**Groundswell  
Gloucester**

**Fundamental Flaws in AGL's application  
to frack CSG wells in Gloucester**

**January 2014**

# Fundamental Flaws in AGL's application to frack CSG wells in Gloucester (Review of Environmental Factors (REF))

**Figure 2: Sample Deep Slotting Cross Section based on Stage 1A Profile Logs**

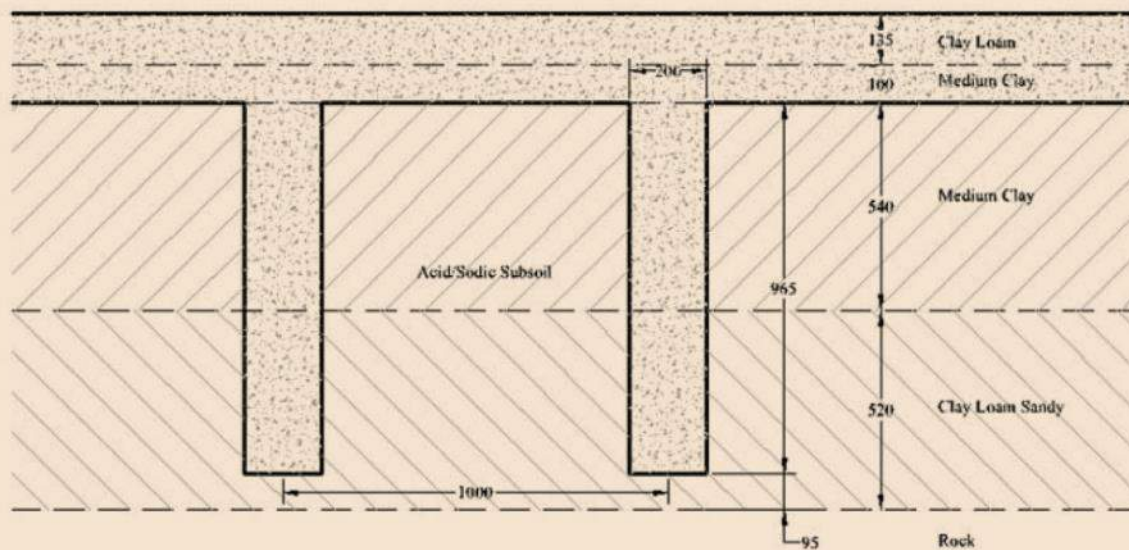
Figure 2 from FK 2012 is copied below and indicates that the slots are 200mm wide and spaced at 1000mm intervals across the surface but FK 2013 says the slots are 1500mm apart. Therefore, 12% of the soil is dug up and the ameliorant mixture is buried. This would not result in a

“thorough mixing of soil ameliorants’ as stated in the paragraph copied above. There will however be subsoil brought to the surface and this is not a good practice on Brown Sodosol soils.

The treatment or composition of the two top layers (135mm and 100mm) in Figure 2 cannot be understood due to lack of information. Section 8 of FK 2012 (reproduced below) provides some more information on this and suggests that the soil removed from the slots and the top 235mm are mixed with the ameliorants; then some of this mixture is put back into the slots and the remainder is spread across the surface at depths varied according to the depth of slots. The soil profile that results from this amount of physical and chemical change will be very complex in both the vertical and horizontal direction. This means that representative sampling will be complicated and require a large number of replications to avoid the bias of the slots.

**FK Report 2012 Figure 4: Stage 1A Trial Irrigation Area showing location of soil sampling site (CS), shallow groundwater samplers (SP, piezometers) and soil moisture sensors (MS)**

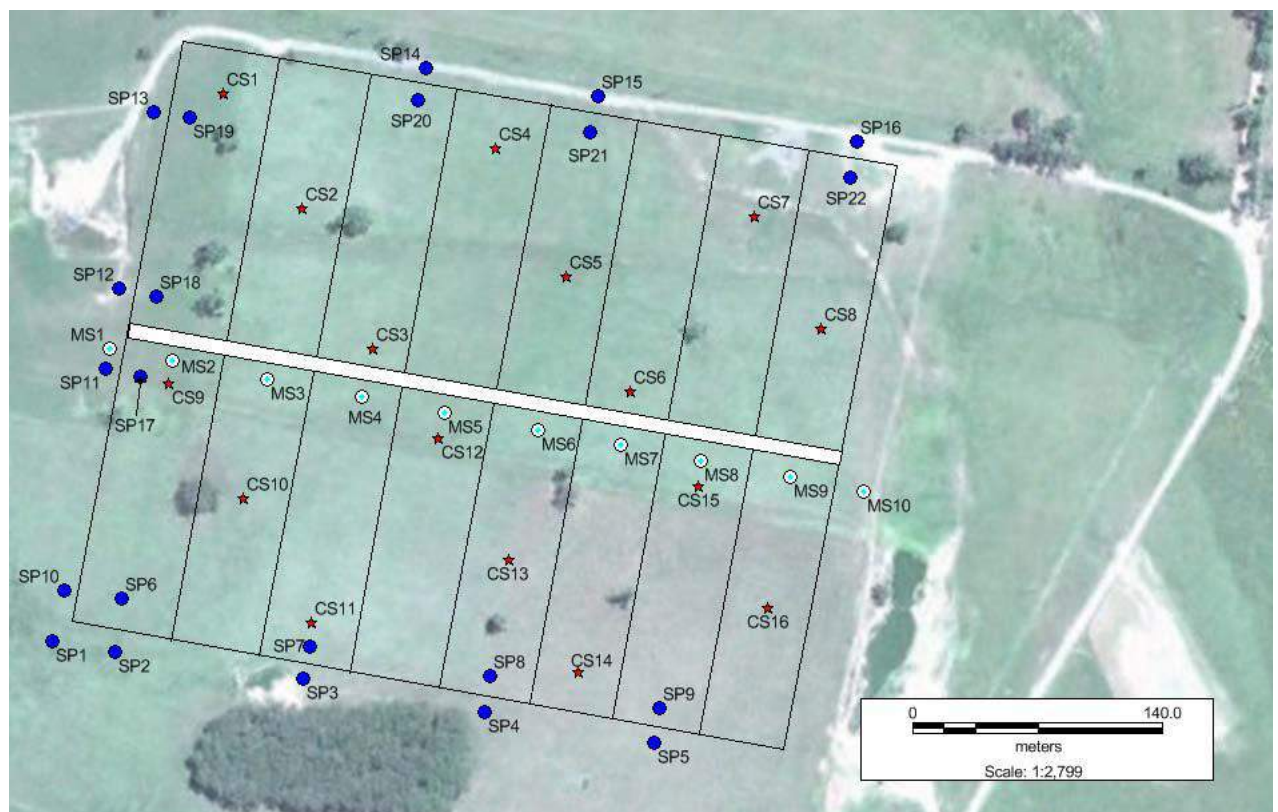
The first dot point is not a reasonable assumption because the variability across the site is so large (FK Annex 1 copied above). A statistical comparison is not possible with such a small sample size.

The second point is not acceptable because the soil surface has been substantially changed due to the trenching process and incorporation of large amounts of 'ameliorants'. FK2013 Appendix 1 (reproduce here on the next page) indicates that there is a height difference of >10m across the site and can vary by 3-5m in any plot with different slope gradients within various plots.

The third point is incorrect because 1 sample per 0.77ha is not a high density of sampling for such analysis due to the very variable nature of the soil and its characteristics. This variability is demonstrated by the data presented (pages 3 - 4 above) from Annex 1 of FK 2012 that shows the minimum to maximum variations are three fold for many characteristics. There should be at least 7 and preferably 9 sample sites for each plot in order to adequately account for within treatment variation. The location of sample points in relation to the amelioration slots is critical to data interpretation but this is not discussed in FK 2012.

Point four is not true. There is not a sample point for soil moisture or groundwater in each plot. Given the large surface gradient differences, and therefore runoff differences within the plots, there should be at least 7 and preferably 9 sample sites for each plot. The moisture difference at various horizontal distances from the slots will be very large and there will also be interactions between depth of slots and distance.

As presented in Figure 4, the soil sampling sites (CS) are somewhat on the contour lines (mapped in Sheet 01A of Annex 1 FK 2013) but this means they bear no relationship to the soil moisture sampling points (MS) and therefore no possible cause and effect relationships can be analysed between soil moisture and any other soil property. Similarly, there is no analysis possible of any relationship between soil moisture (MS) and groundwater (SP) because of the large spatial differences between sampling sites.

Figure 6.3 Travel time for overland flow

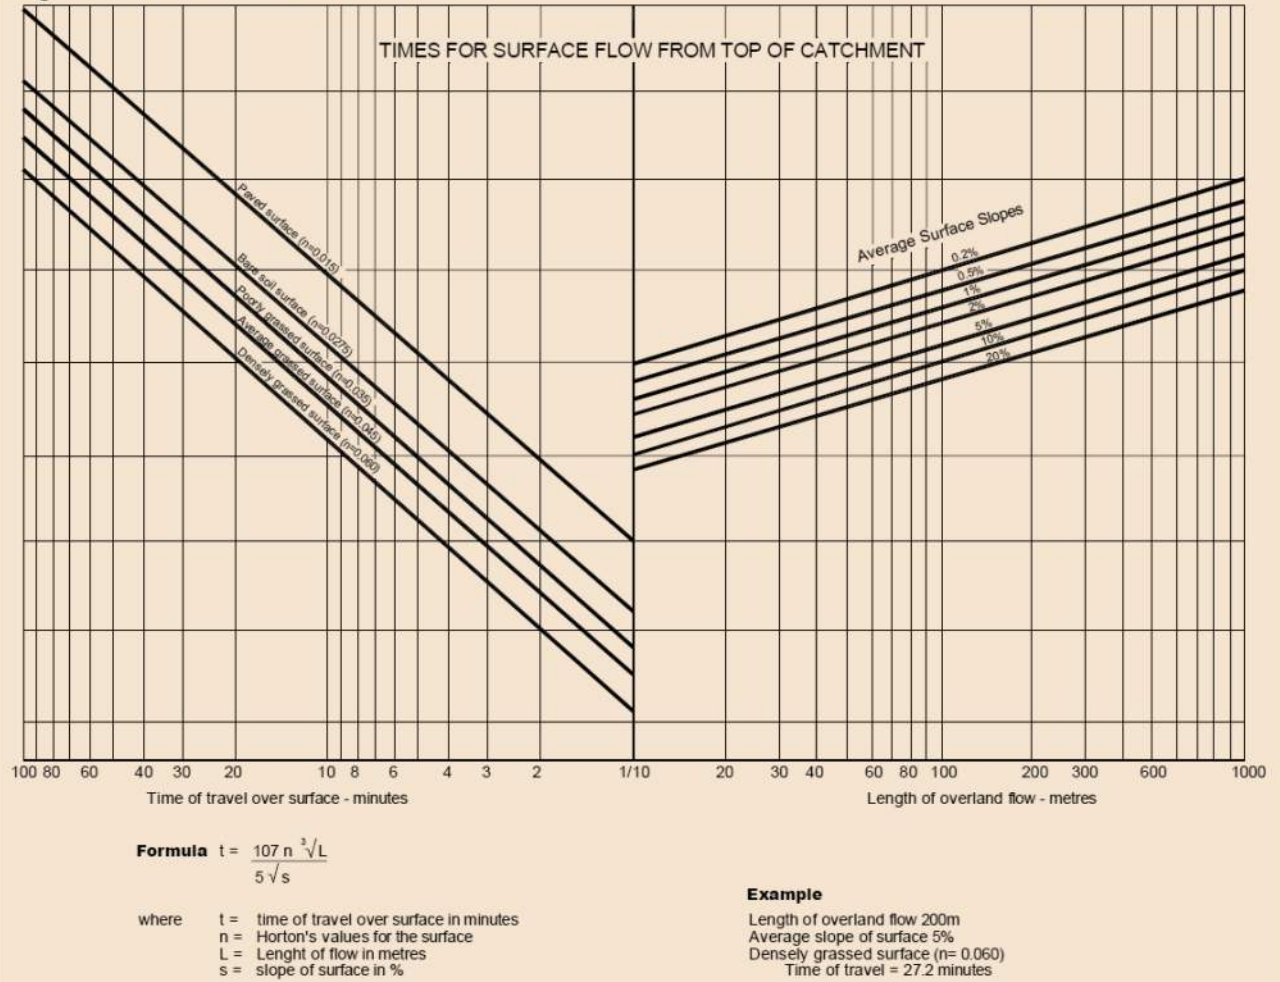
From the data in FK 2012 Table 4 the 32 minute rainfall intensity would be 100mm/hr for a 1:100 year rainfall event. That is, a depth of 100/2 or approximately 50mm total rain in the 32 minutes that the furthest runoff took to reach the catch dam. With a runoff coefficient of 0.2 used in the FK 2012 report this means that total runoff for the 12.32 ha will be  $123,200\text{m}^2 \times 0.2(\text{coefficient}) \times 0.05\text{m}(\text{rainfall}) = 1232\text{m}^3$  of water. This is 4 times the  $310\text{m}^3$  volume of runoff which the FK 2012 report calculates. The catch dams will overflow in a 1:100 year rainfall event and discharge polluted water into the surrounding land and watercourse

The pump on the catch dams has a capacity of  $26\text{L/s} = 26/1,000 \times 60 \times 60 \text{ m}^3/\text{hr} = 93.6 \text{ m}^3$  so it will take 3 hours to empty the dams and in the meantime  $900\text{m}^3$  of polluted water will have escaped.

The whole calculation of volumes for the catch dams is flawed due to an incorrect use of the Rational Method. The FK 2012 report on page 11 contains the following paragraph that is meaningless.
